BELLOWS ADDITION

RE: SUB 2000-51 -- One-Step Final Plat of BELLOWS ADDITION

RE: SUB 2000-51 -- One-Step Final Plat of BELLOWS ADDITION

SUB 2000-51 -- BELLOWS ADDITION

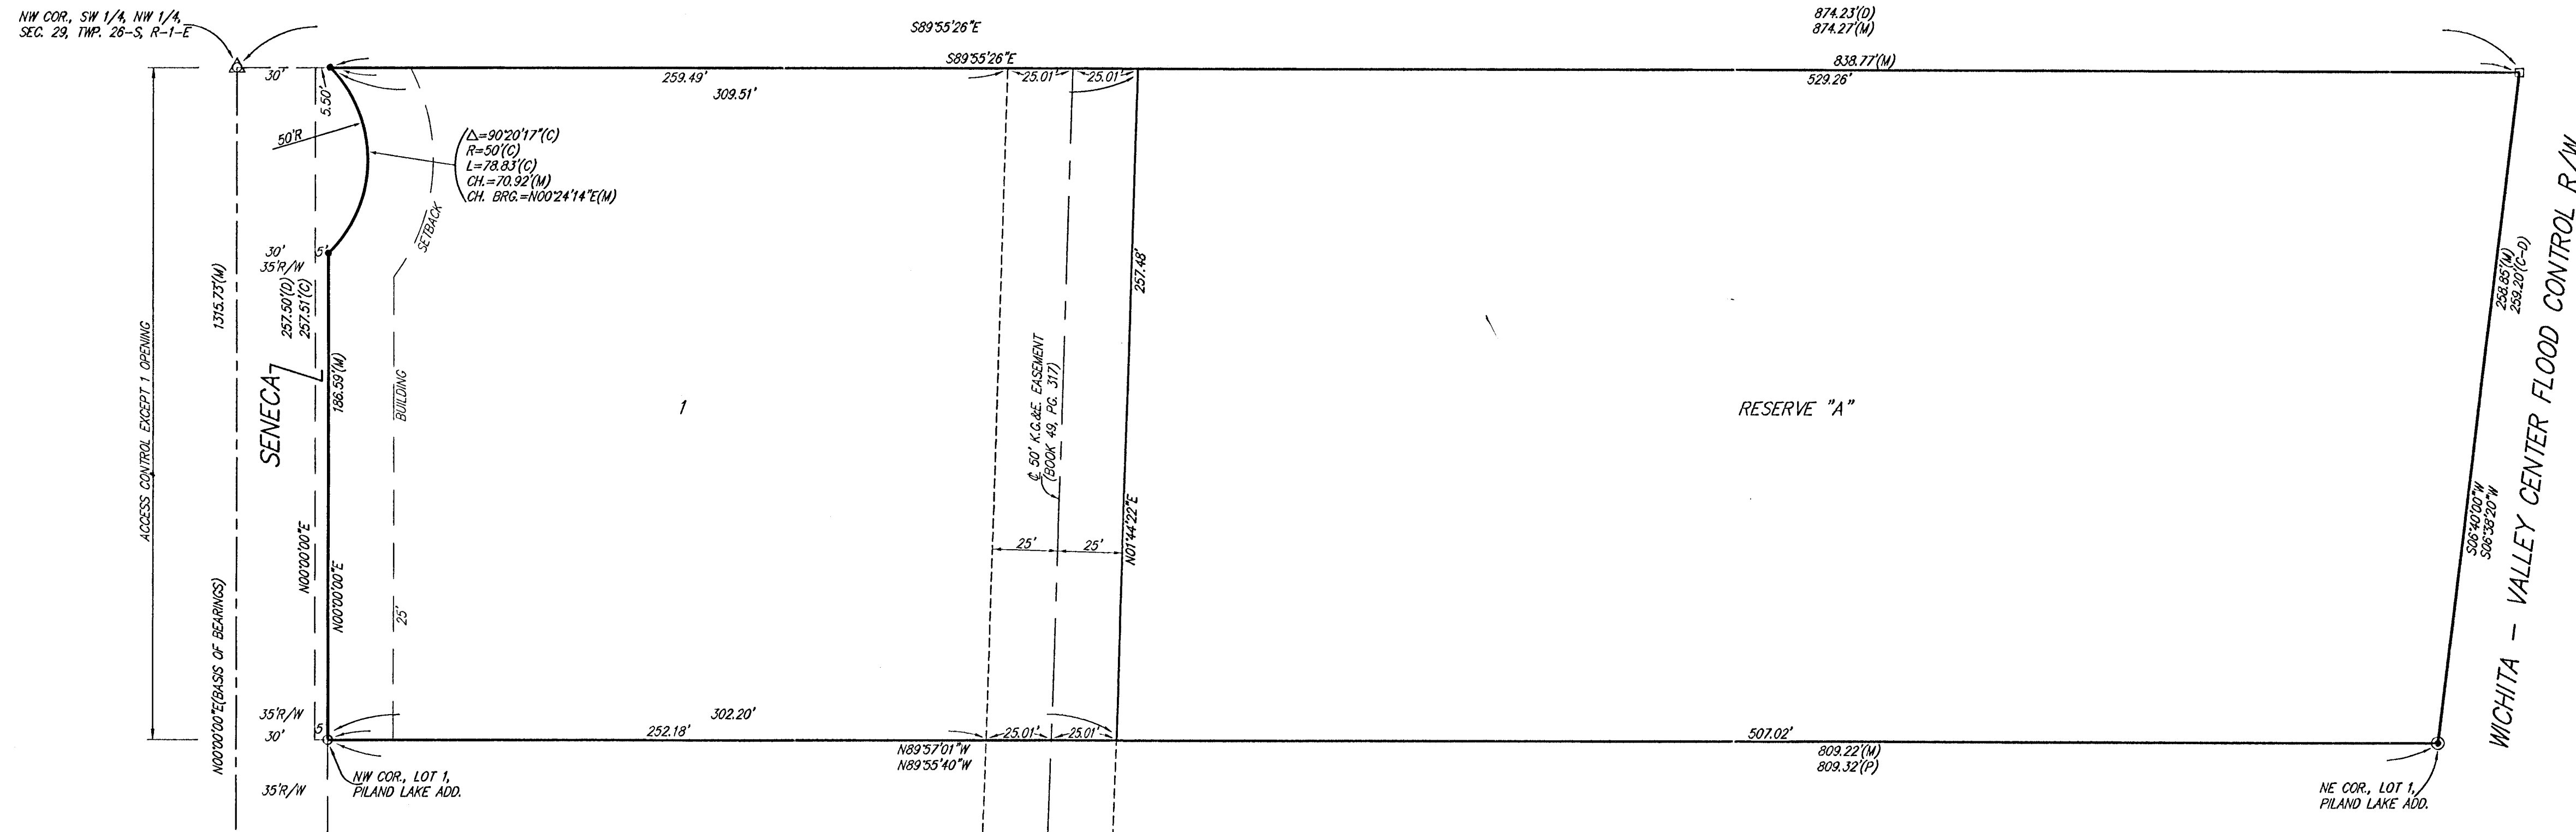
- D. City Engineering needs to comment on the status of the applicant's drainage plan and the need for the platting of a Floodway Reserve for the existing lake. A Floodway Reserve should be platted for the eastern portion of the property.

- E. Traffic Engineering needs to comment on the need for access controls. The final plat tracing shall reference the access controls in the platlor's text. Traffic Engineering has approved access control except for one opening along Seneca.

- G. Due to the excessive lot depth, City Fire Department needs to comment on the need for a maximum building setback to accommodate fire prevention equipment. The plat shall include a Floodway Reserve along the eastern portion which would limit construction.

- H. The lot depth to width ratio exceeds 2.5 to 1 and a modification from the Subdivision Committee will be required. A modification is approved.
- I. The 50-foot KG&E easement needs sufficient ties to locate it definitely with respect to the subdivision.

- J. The plat's text shall include language that a drainage plan has been developed for the plat and that all drainage easements, rights-of-way, or reserves shall remain at established grades or as modified with the approval of the applicable City or County Engineer, and unobstructed to allow for the conveyance of stormwater.
